DA number: 10.2014.724.2

Chris Lonergan – Town Planner, Design, BASIX, Landscaping, Ecology, Bushfire Assessment.
Email – chris@byronbayplanning.com.au

Objection to S4.55 to Modify Consent to include Eight (8) Additional Motel Units, Remove the Ground and Third Floor Swimming Pools, Add a Roof Top Recreation Area comprising a Swimming Pool, Bar and Cafe Spaces, DA 10.2014.742.2

Lot 18 Sec 8 DP 758207 No. 33 Lawson St. Byron Bay.

Southern Elevation Max Height Proposed - 14.67m.

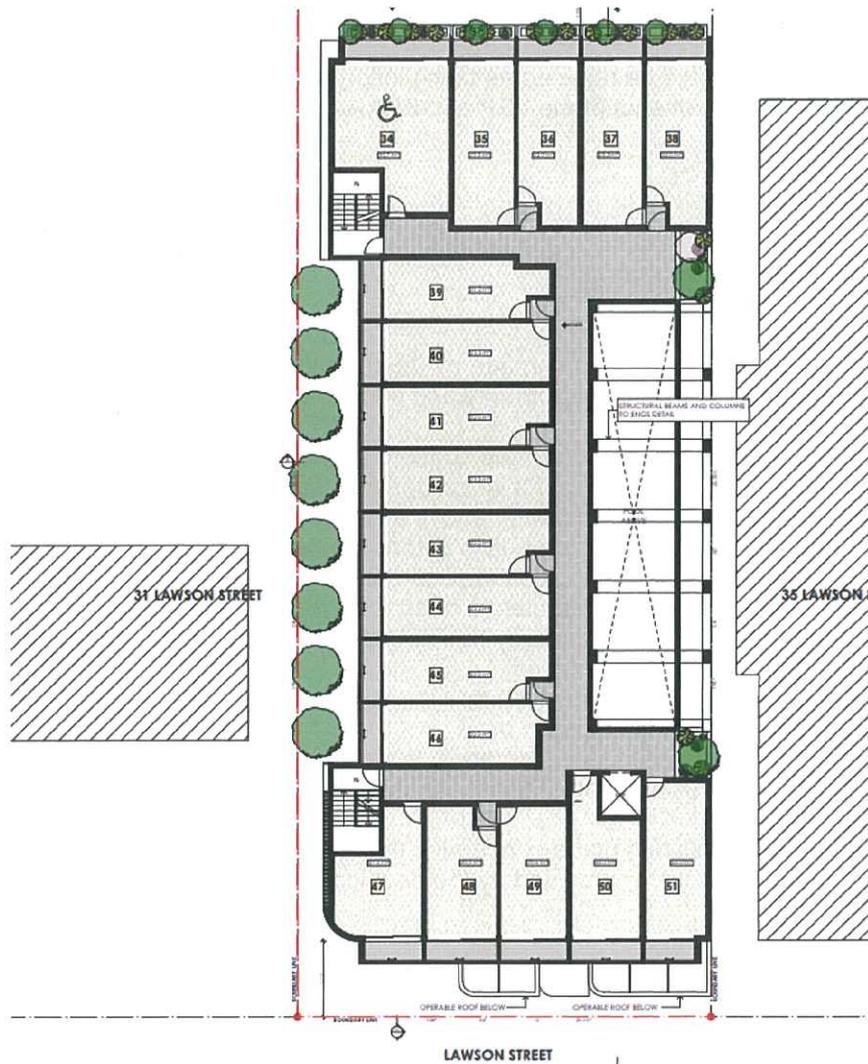
The proposed inadequate and incongruous design, not only offends the amenity of the area as a result of its bulk and scale, but the design also causes a significant loss of amenity to the adjacent residences to the west at No 31 Lawson Street, with noise from the entertainment areas, and overlooking balconies.

This is an unacceptable design outcome for the Medium Density Residential Units.

The design is also at odds with not only the existing streetscape, parking, and design guidelines set within DCP 2014 and the Byron LEP 2014, but the loss of natural sunlight to the west.

Height of Buildings Map - Sheet HOB_003CC

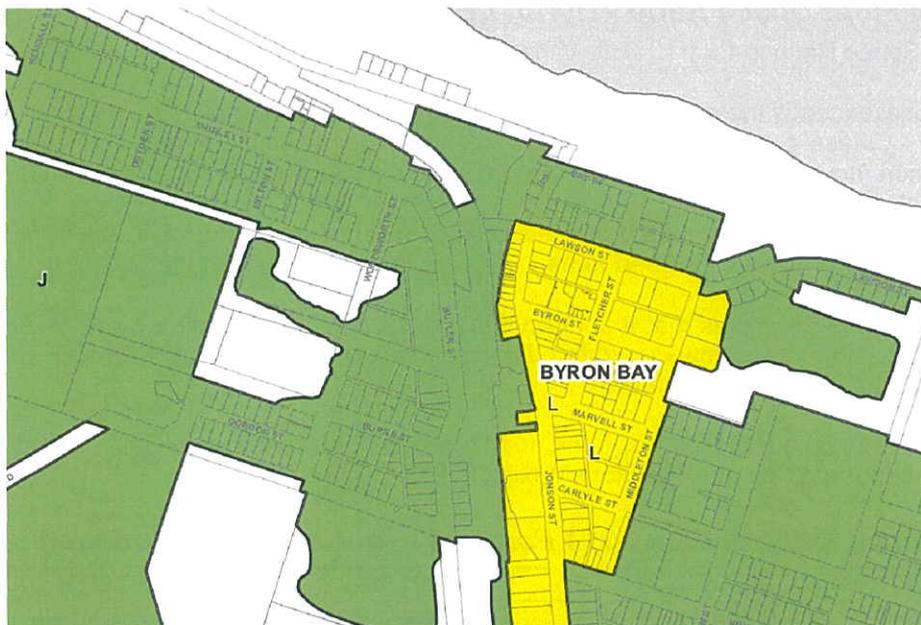
The proposal exceeds the maximum Statutory Height Limit by 5.67m. That is a 63% variation from the Maximum 9m permitted.

Byron LEP 2014 - Clause 4.6 Exceptions to development standards, would permit Council to consider a variation, however no formal request to vary the Development Standard accompanies the Sec 4.55 Application.
